TECHNICAL NOTE ADDENDUM ON FLOOD RISK AND DRAINAGE

PROJECT	Eastleigh Court, Warminster	PROJECT / REF	S250204-TN01
CLIENT	Kindred Living Project Ltd	REVISION	01
AUTHOR	Nathan Rowe BSc (Hons), IEng MICE	DATE	01 Oct 2026

This addendum note has been prepared in response to the Lead Local Flood Authorities objection to the initial submitted Flood Risk Assessment and Outline Drainage Strategy report, report ref S250204-SUB-99-XX-FRA-C-00001 revision 03, for planning application ref PL/2026/01607 at Eastleigh Court, Bishopstrow, Warminster, BA12 9HW. The holding objection is dated 22/04/2026.

Figure 04 – Ground and Groundwater Model (Soil and Structures Hydrogeological Assessment Extract)

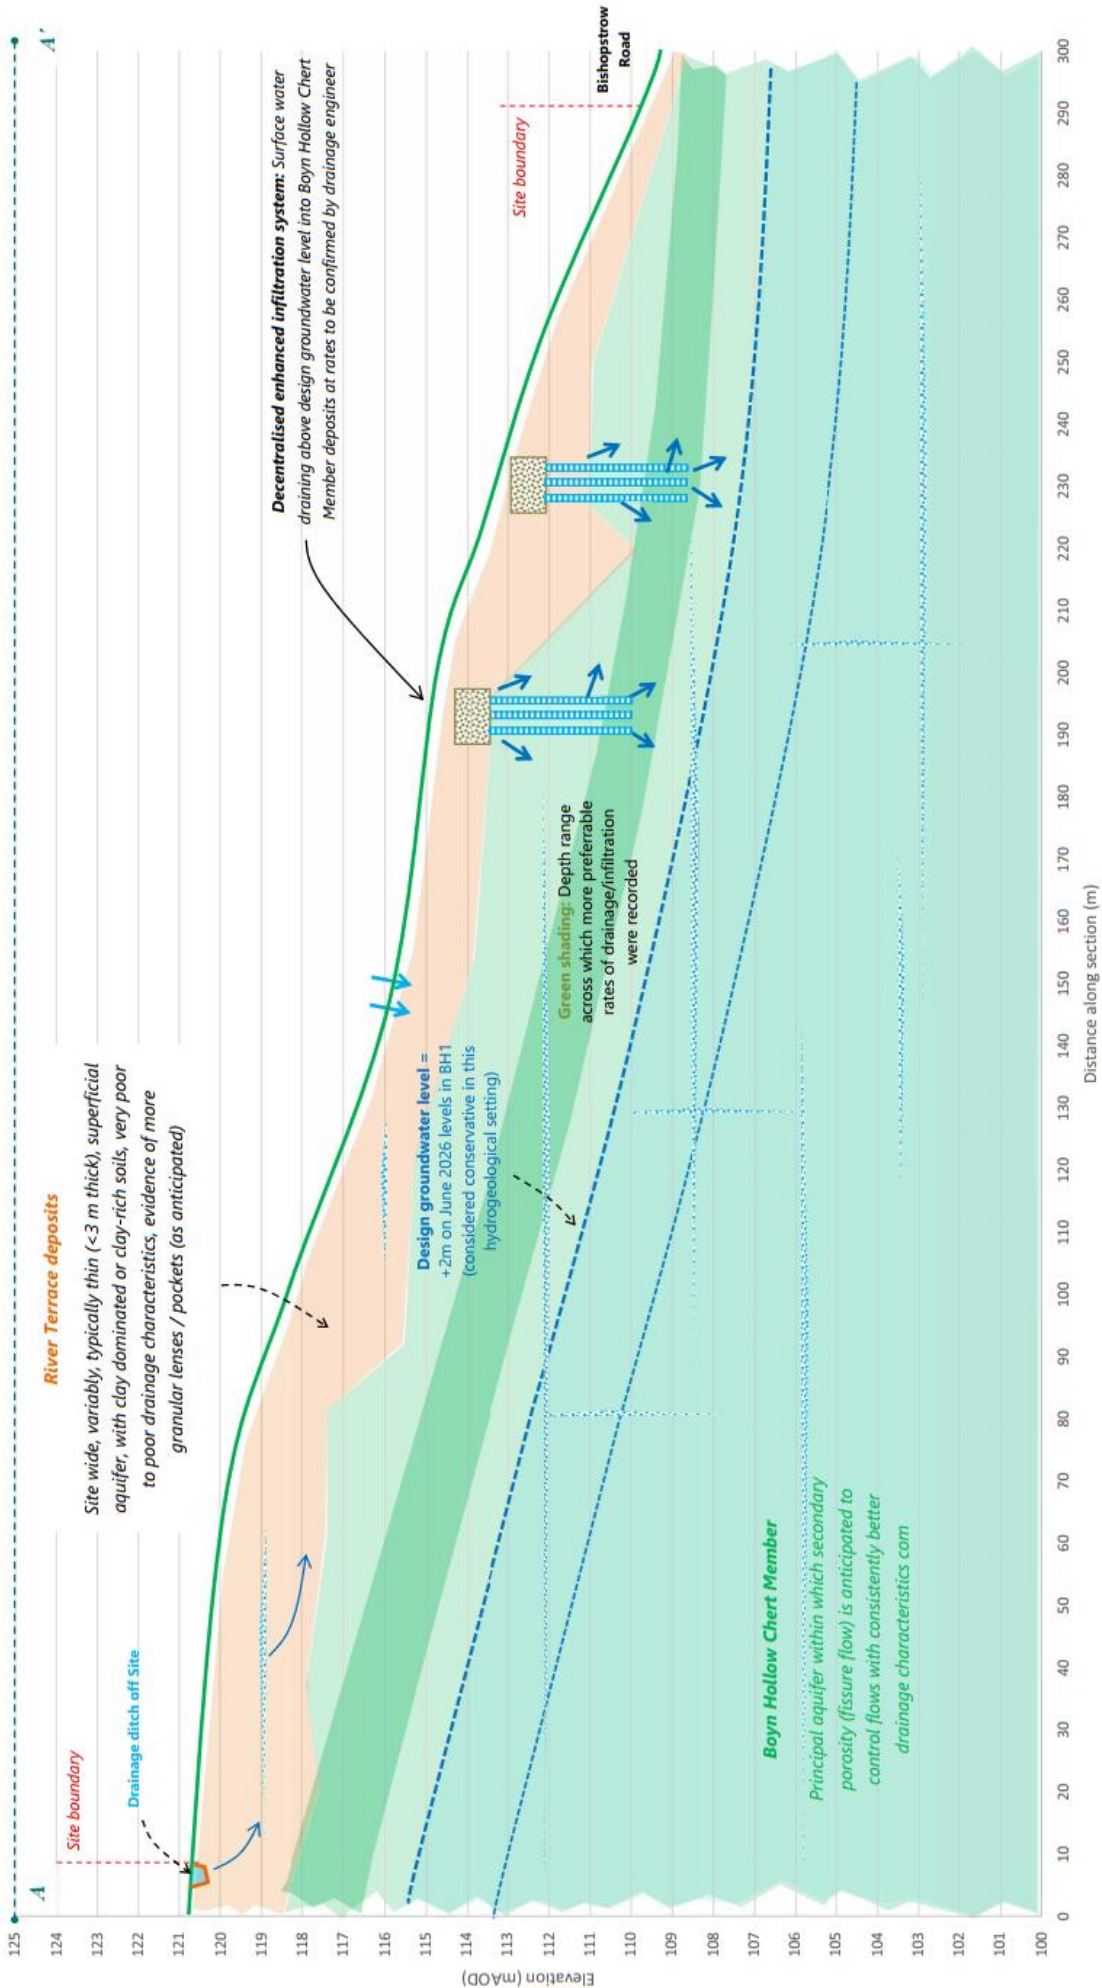
Noting the applicant may proposed deep infiltration devices – there must be 1m clearance between the base of infiltration feature and groundwater to prevent interaction. Additionally as noted by the applicant, the EA must be consulted on deep soakaway devices...

EC49 have advised that the invert/depth of the ECO90 devices should be limited to 6mBGL (below ground level) to remain clear of groundwater (with 2m freeboard) as shown on Figure 04, discharging into the Boyn Hollow Chert Member where preferable rates of drainage/infiltration were recorded. The total length of the ECO90 devices will be approximately in 4.5m lengths, to cater for permeable car park construction and/or attenuation situated above the ECO90 units.

Figure 05 – Outline Drainage Masterplan Mark-Up

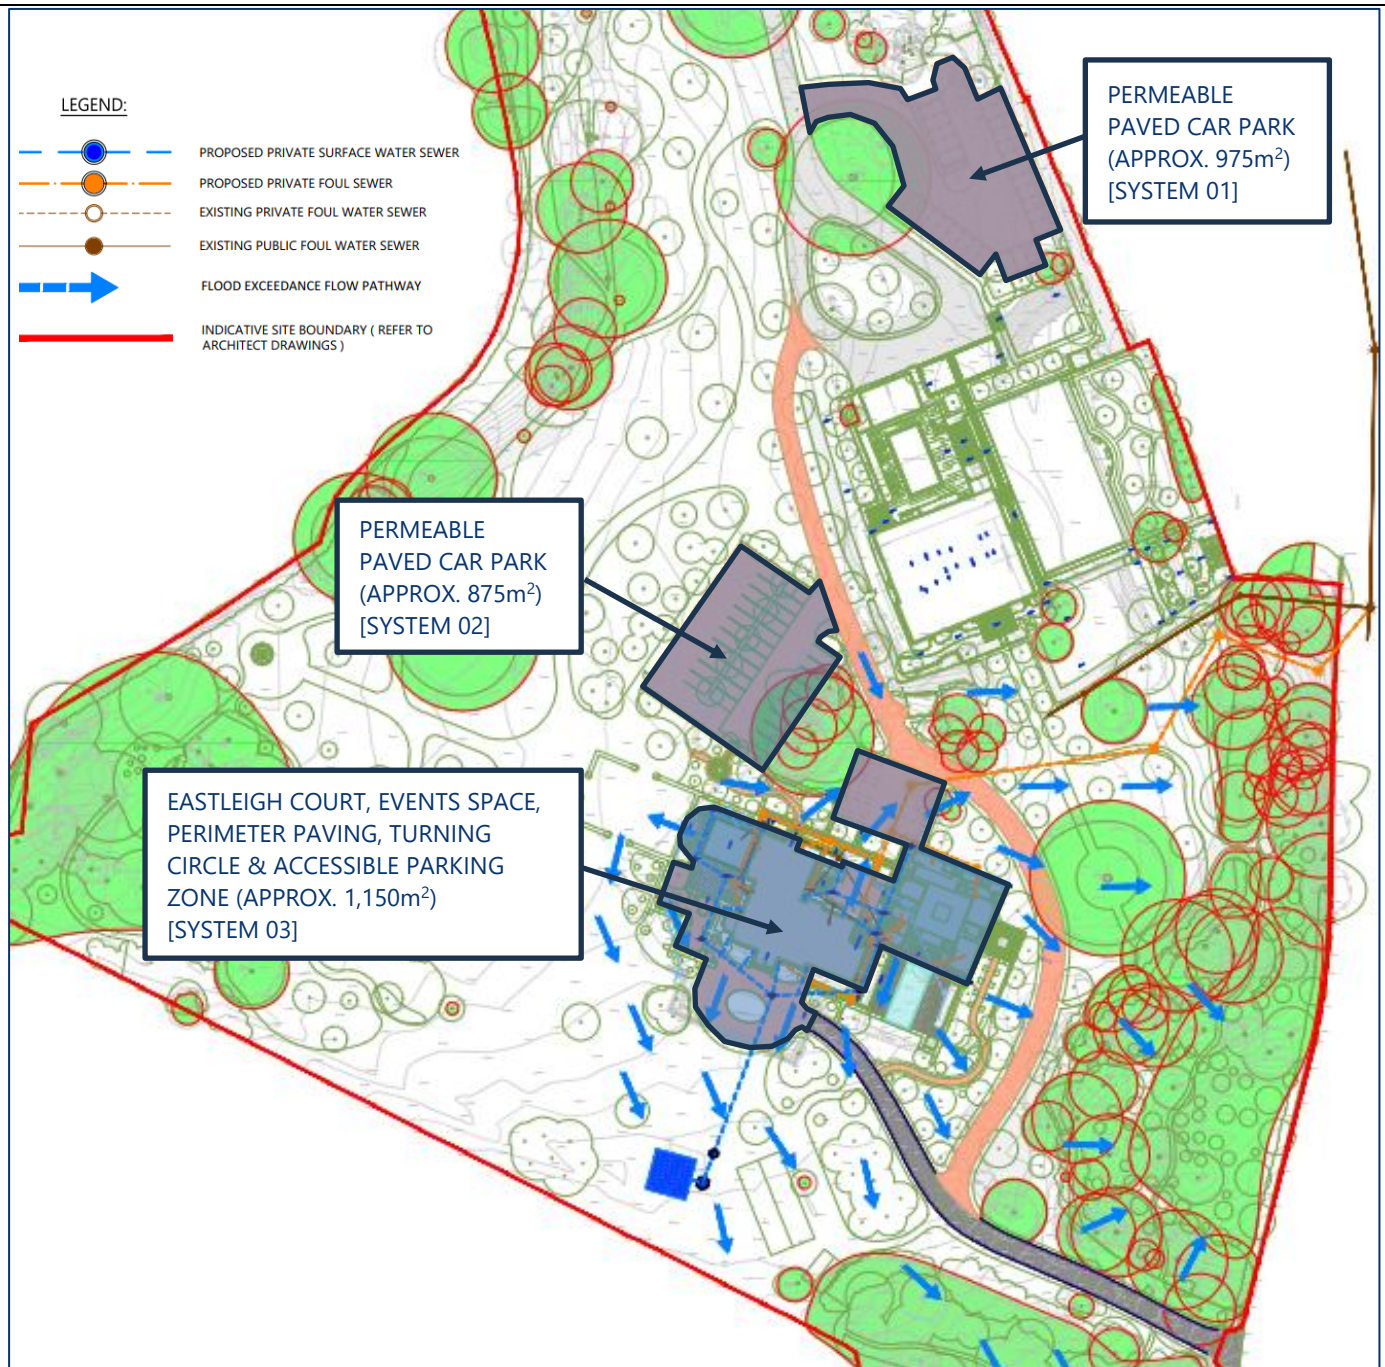
"At this stage, it is not clear there is a feasible drainage strategy due to the uncertainty regarding infiltration at the site. While acknowledging the applicant has stated further BRE365 compliant infiltration testing will be undertaken, this information is required at this stage to demonstrate there is a safe and feasible surface water drainage strategy in principle.

System 01 will utilise the soakage rates identified within TD01, System 02 will utilise TD02 infiltration rates and System 03 will utilise TD03 infiltration rates.

It is envisaged that Systems 01 and 02 will utilise storage attenuation within the porous subbase, with ECO90 units situated beneath the porous subbase, allowing for water to percolate through the surface paving and subbase, removing pollutants as water percolates before infiltrating into the ground via the ECO90 units. The exact detail will be determined during the detailed design by Groundwater Dynamics.

System 03 will drain with a below-ground pipe network towards an attenuation tank located to the south, as

depicted on the outline drainage drawings. The attenuation tank will be unlined, allowing for infiltration. Water will pass through the tank directly into ECO90 units beneath, before infiltrating into the ground.
